Braidwood Station, Units 1 and 2
Facility Operating License Nos. NPF-72 and NPF-77
NRC Docket Nos. STN 50-456 and STN 50-457

Byron Station, Units 1 and 2
Facility Operating License Nos. NPF-37 and NPF-66
NRC Docket Nos. STN 50-454 and STN 50-455

Subject: Request for Amendment to Technical Specifications for Byron and Braidwood Stations to Implement the Best Estimate Analyzer for Core Operations Nuclear Power Distribution Monitoring System

In accordance with 10 CFR 50.90, Commonwealth Edison (ComEd) Company is requesting a change to Appendix A, Technical Specifications (TS) of Facility Operating License Nos. NPF-37, NPF-66, NPF-72 and NPF-77, for Byron Station, Units 1 and 2, and Braidwood Station, Units 1 and 2, respectively.

Figure 2.7.2 Axial Flux Difference Limits as a Function of Rated Thermal Power

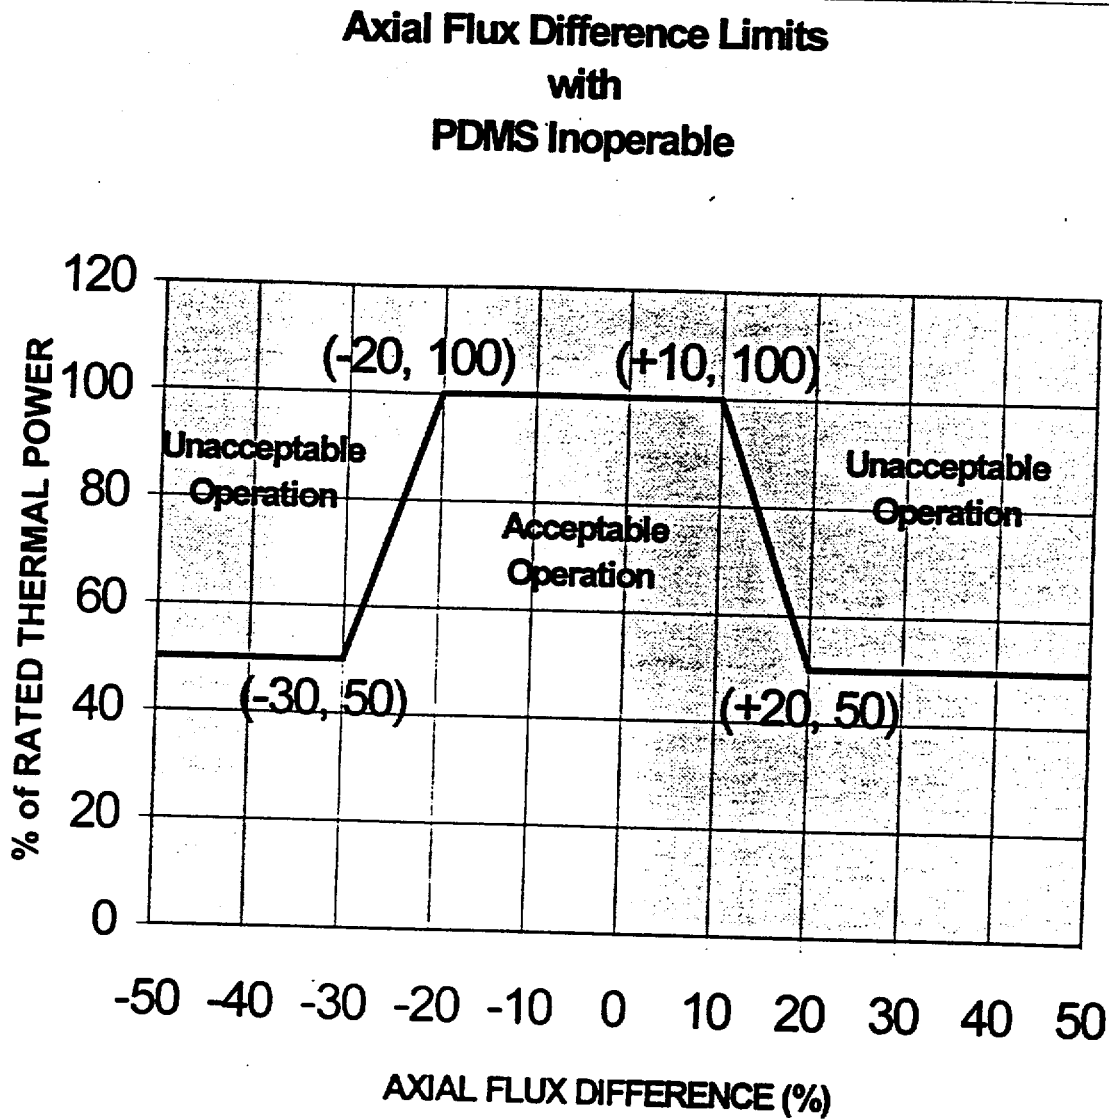
2.7.2 When PDMS is inoperable, the AFD Acceptable Operation Limits are provided in Figure 2.7.2 or the latest valid PDMS Surveillance Report, whichever is more conservative.

Figure 2.7.2 Axial Flux Difference Limits as a Function of Rated Thermal Power

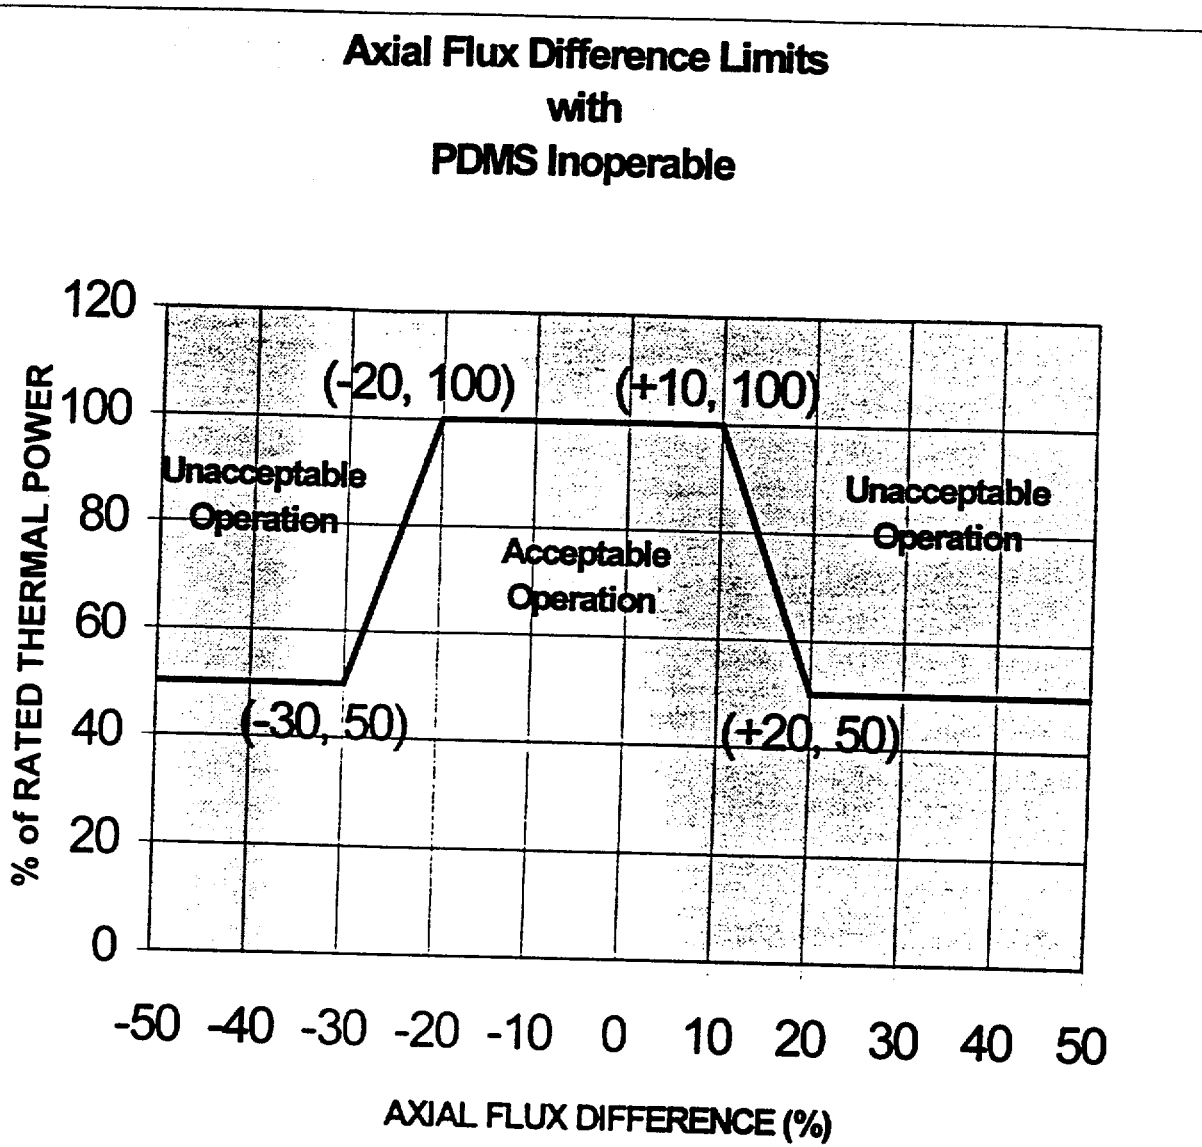
2.7.2 When PDMS is inoperable, the AFD Acceptable Operation Limits are provided in Figure 2.7.2 or the latest valid PDMS Surveillance Report, whichever is more conservative.
